Mondol Fashion Ltd

Rashid Tower, Tongabari, Asulia, Savar
(23.90585, 90.32248)

8th April 2014

Observations

Ground Floor (Semi-Basement) Floor Plan

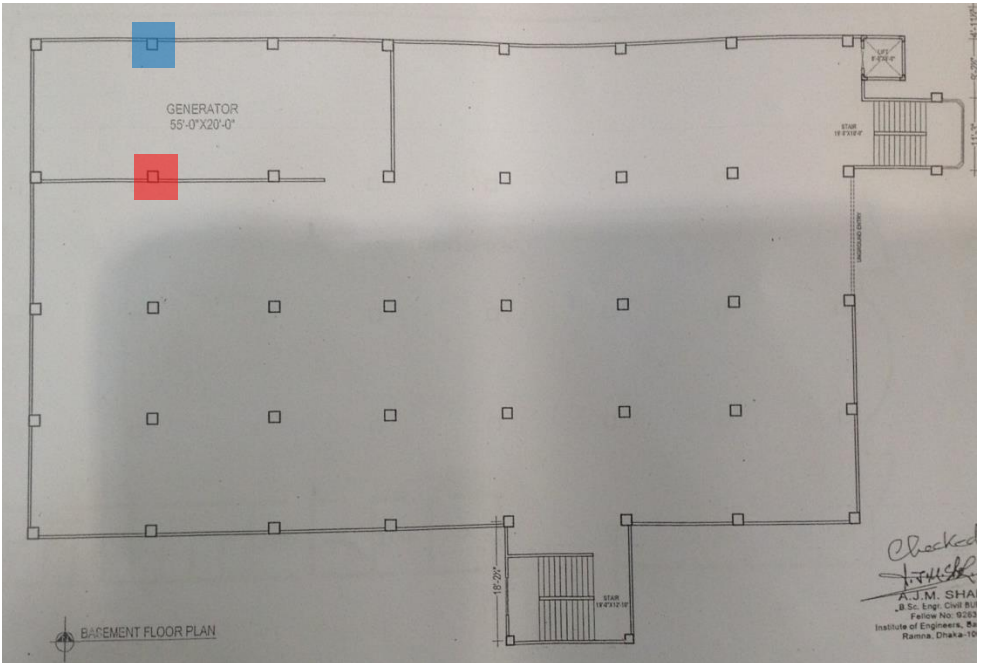
Cursory calculations indicate that the working stress of the columns at Ground Floor and First Floor levels are at a high level. Refer to Action 1.

Construction of the building began in 2006, with construction of Foundations up to 2nd Floor level completed in 2007. Levels 3, 4 and 5 were subsequently constructed between 2012 and 2013. Stone aggregate was noted in the Ground Floor (or semi-basement) columns, although brick aggregate was observed at the head of one of the exposed columns at the intersection with the 1st Floor Slab. It is understood that the columns up to 2nd Floor level have stone aggregate and all other structural concrete members contain brick aggregate. There is a discrepancy between the drawings and the constructed building in relation to the size of the columns at Basement level. The columns were observed to vary in size in a random manner, and are typically smaller than is indicated in the drawings. Steel reinforcement quantities were also observed to be smaller than is indicated in the drawings. Grade 72 High Strength steel, which is called up in the structural drawings, was observed in the columns at Roof level.

Item No.	Observation	Recommended Action Plan	Recommended Timeline
1	Stress levels in Columns	Factory Engineer to investigate aggregate type used in each individual column at Ground and First Floor levels particularly at column top level.	6-weeks
2	Stress levels in Columns	Factory Engineer to review design, loads and columns stresses in all columns using a model based design check to loading set out in BNBC-2006	6-weeks
3	Stress levels in Columns	Factory Engineer to verify insitu concrete strength by taking 100mm diameter cores from 4 columns . Verify grade of steel reinforcement used	6-weeks
4	Stress levels in Columns	Make structural alterations as advised by Engineer	6-months
5	Heavy floor loading in and toilet areas	Engage an Engineer to investigate the floor loading, and advise on any necessary alterations taking account of floor capacity and column capacity	6-weeks
6	Heavy floor loading in and toilet areas	Make any structural alterations as advised by Factory Engineer	6-months

Exposed Rebar to Roof

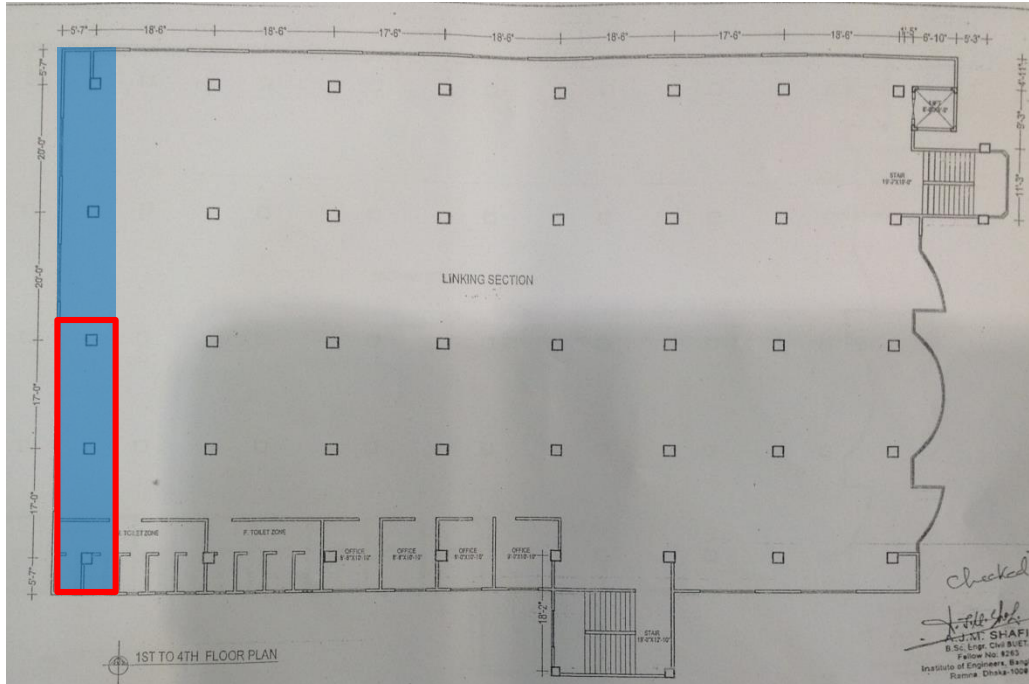
High strength reinforcement steel bars were observed at Roof level. The number of bars observed at Roof level is comparable with observations at basement level using the ferros scanner, but is inconsistent with what is indicated in the Structural Drawings.

Exposed Column A/2
Hairline cracks were noted to column head. This prompted the removal of plaster, which revealed different aggregate types used in distinct concrete pours for the same column.

Typical Floor Plan

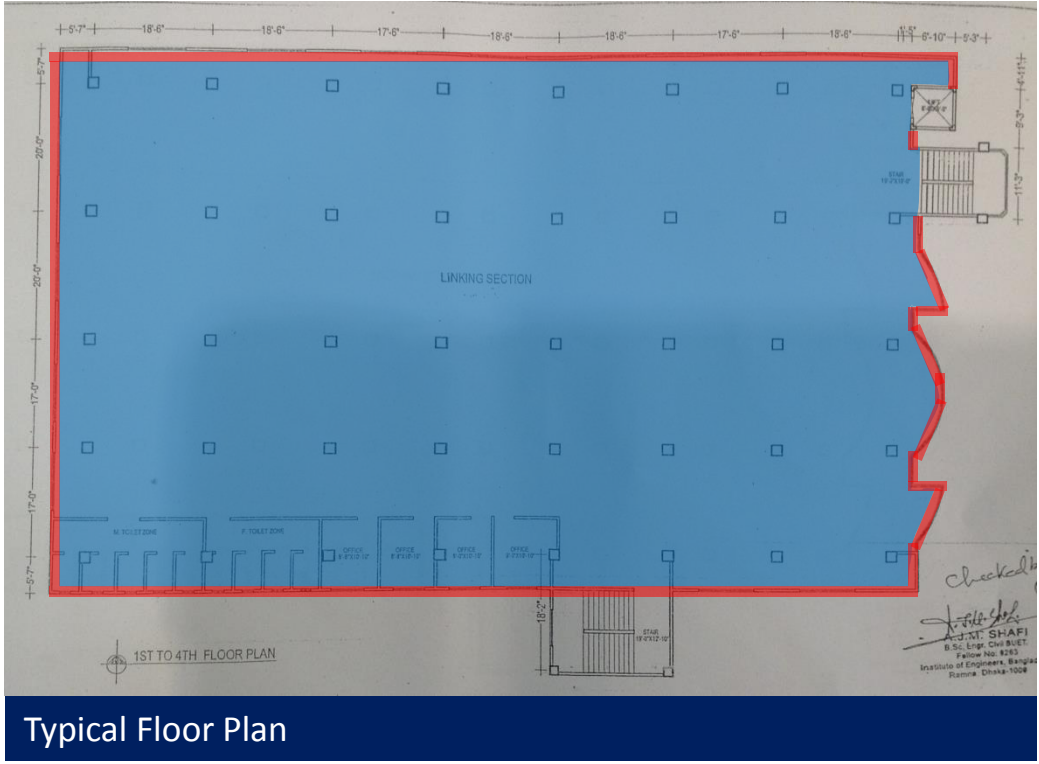
Areas of high super dead loading were noted in the toilets along the West elevation of the building at the cantilever location, in the form of plinths, suspended slabs and walls. Building Engineer to check that the cantilevers have been adequately designed to accommodate this loading.

Edge Protection

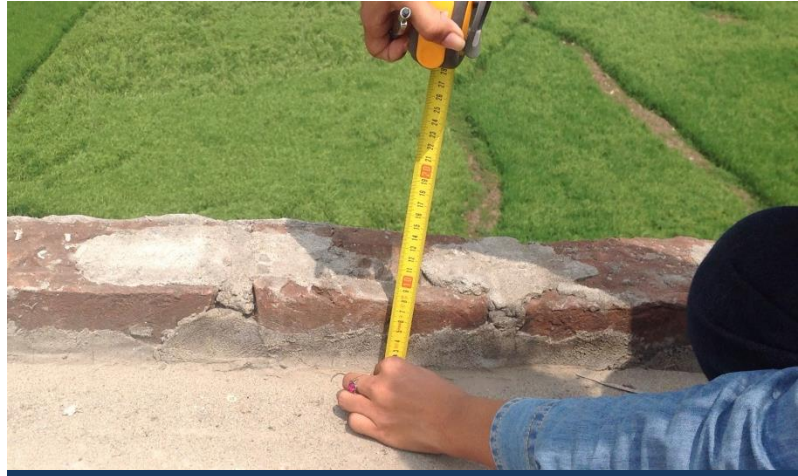
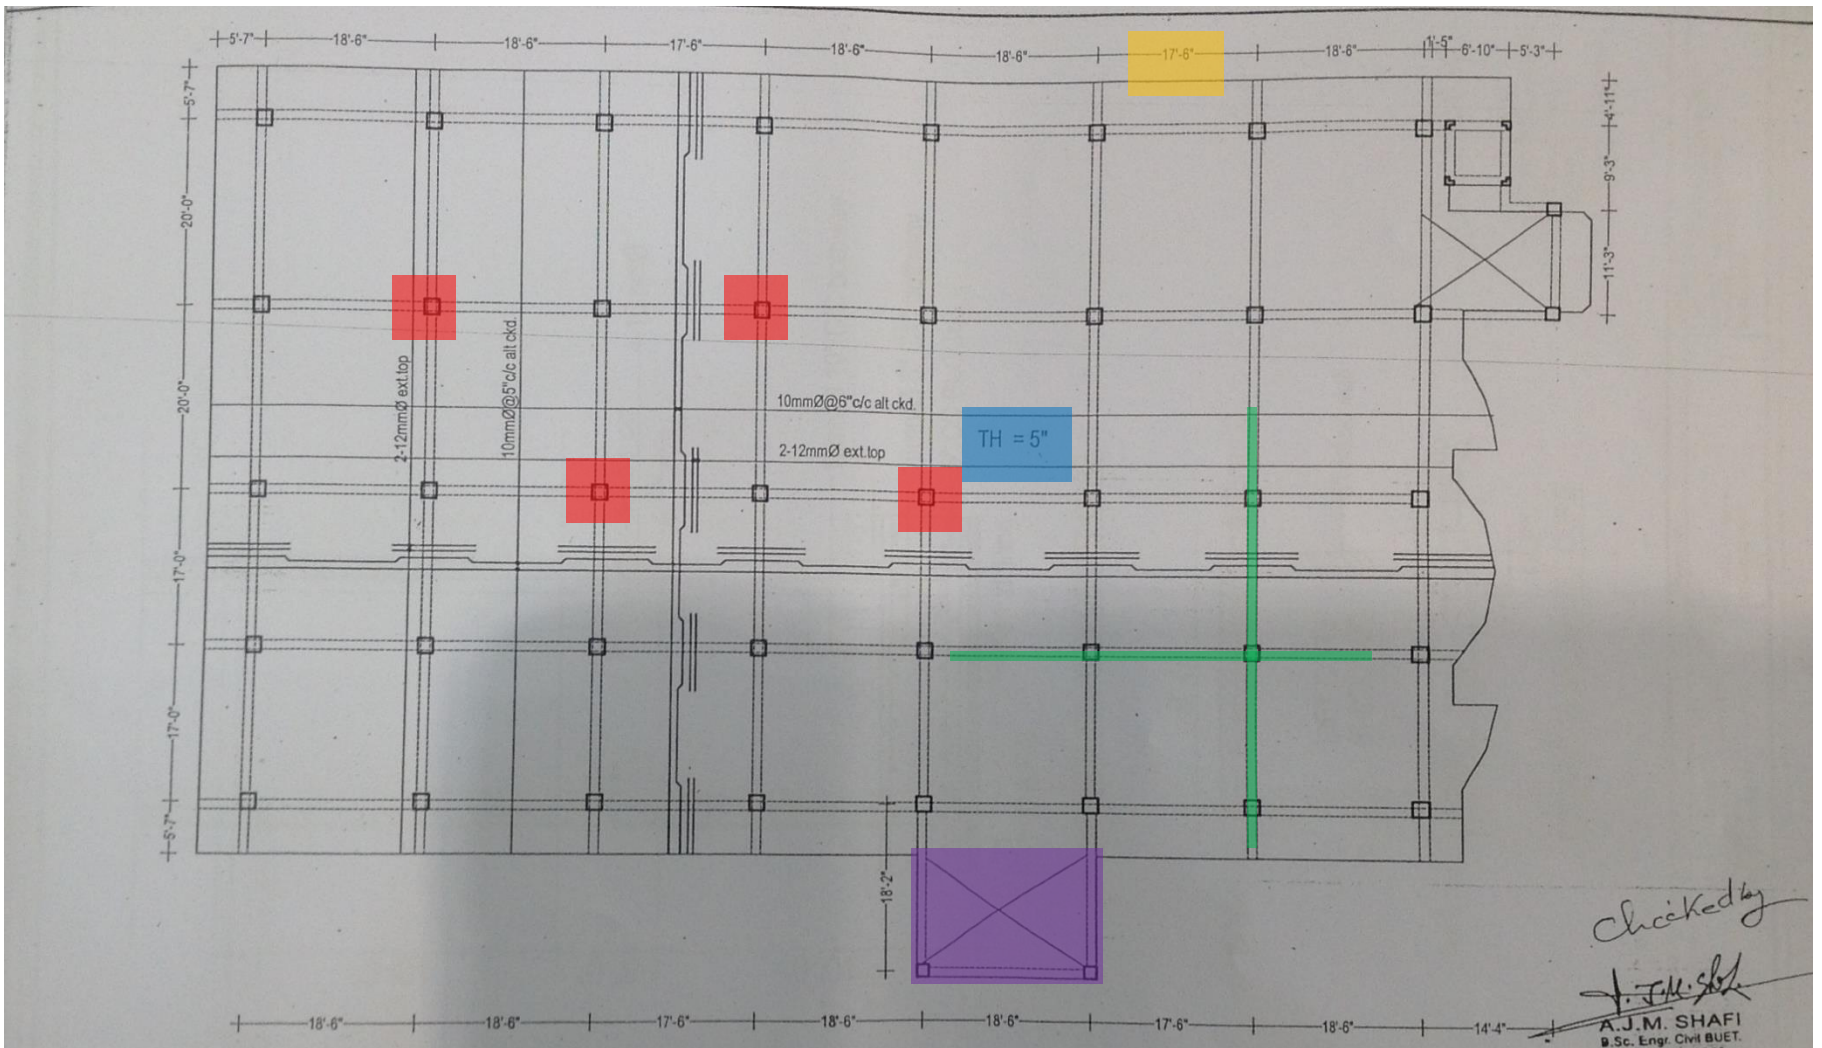
There is no edge protection at Roof level where works are ongoing. Handrails are also missing to stairs. Building Engineer to install adequate fall barrier / guarding with immediately effect.

Lack of Fall Barrier to Roof

7	Lack of any guarding/edge protection at Roof Level and at some stairs levels	Provide adequate edge protection at Roof Level and at stairs	6-weeks
8	Differences between actual construction and information on design drawings	Engage an Engineer to survey the structure and prepare a full set of "as-constructed" drawings	6-weeks

Typical Floor Plan

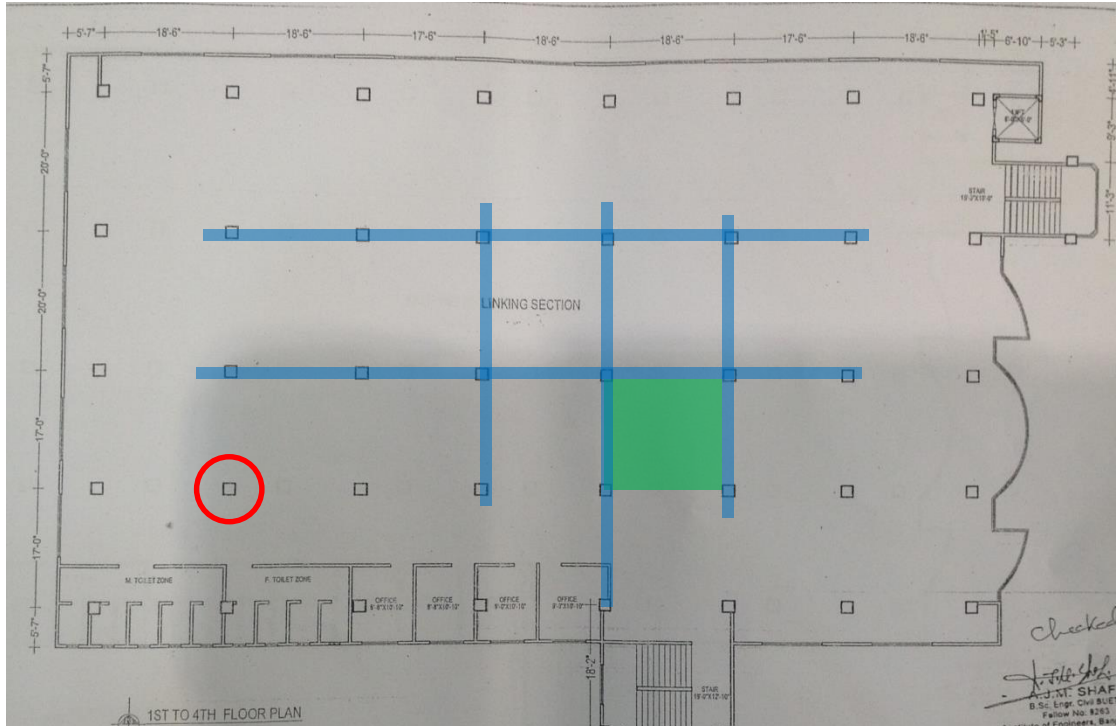
Hairline cracking was observed to the soffit of a number of beams and slabs at Ground, 2nd, 3rd, and 4th Floor levels. Building Engineer to investigate and carry out remedial works to the structure as required.

Non-exhaustive extent of cracking to beams to 2nd, 3rd & 4th Floors

Item No.	Observation	Recommended Action Plan	Recommended Timeline
9	Hairline cracking in beams and slab soffits	Monitor cracks on beams. Engage an engineer to investigate if cracks are only in the plastering	6-months
10	Hairline cracking in beams and slab soffits	Engage an engineer to advise on load reduction and repair and strengthening of the beams if required	6-months
11	Apparently non engineered roof structure to Generator Room	Building Engineer to check the capacity of the lightweight roof and make any necessary alterations	6-months

Location of cracking to 4th Floor slab

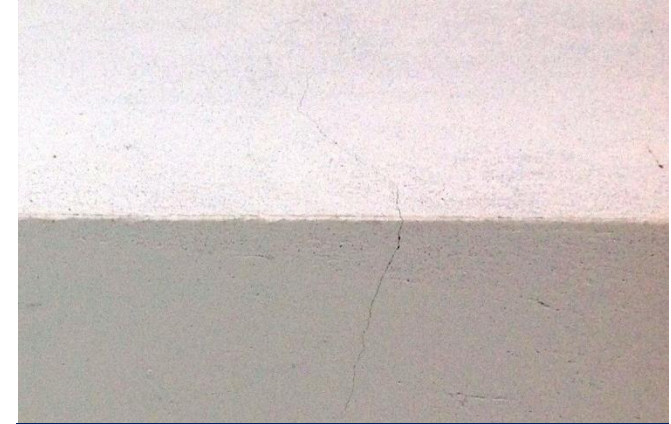
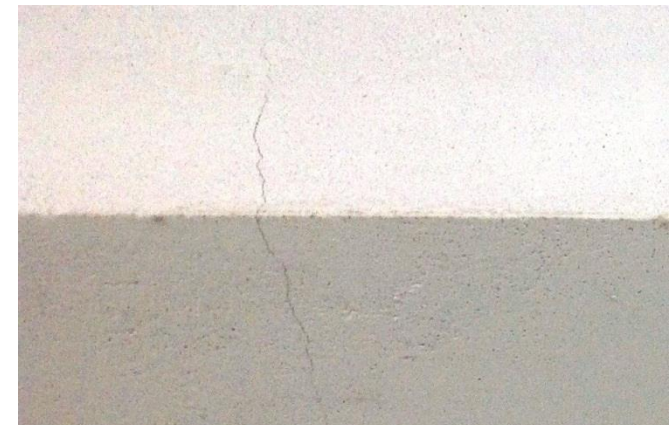
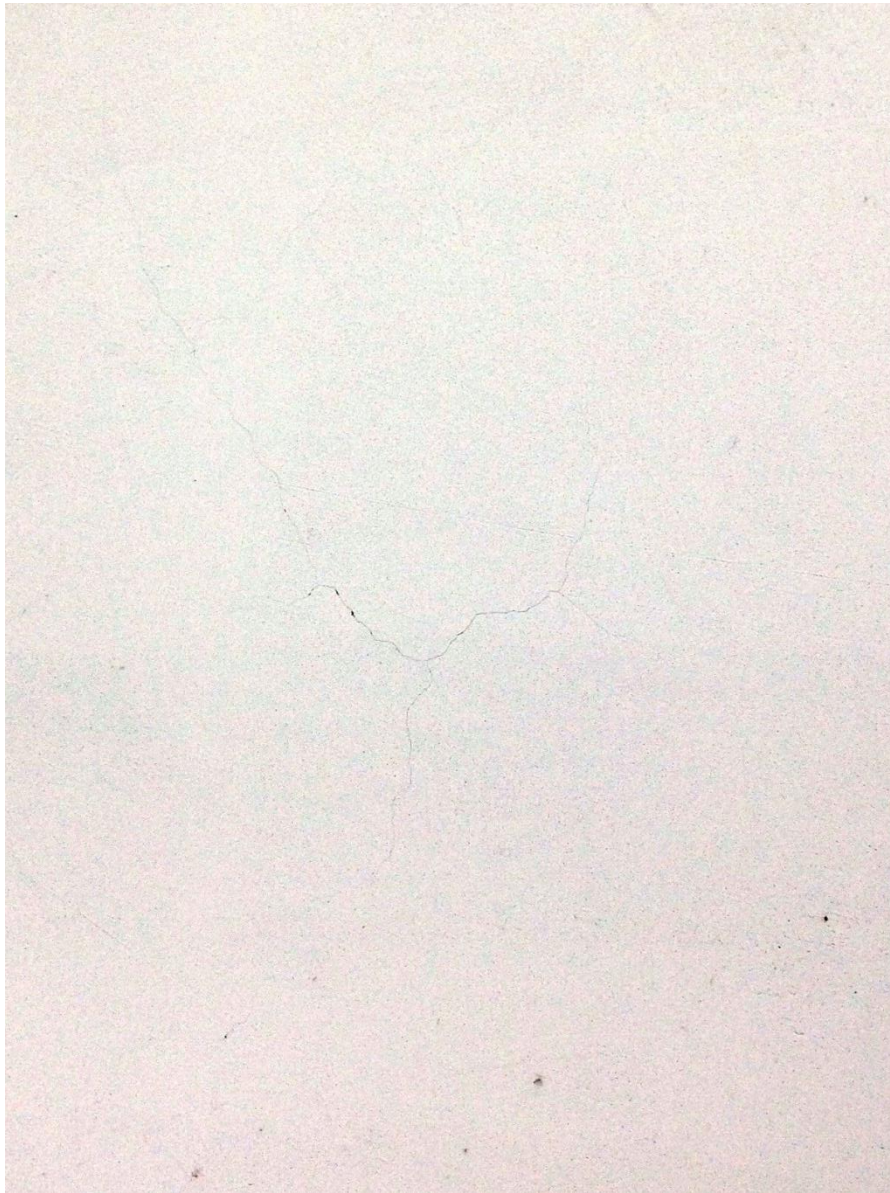
Cracking to underside of beam

Cracking to underside of two-way spanning slab

Cracking to underside of flat slab adjacent to column
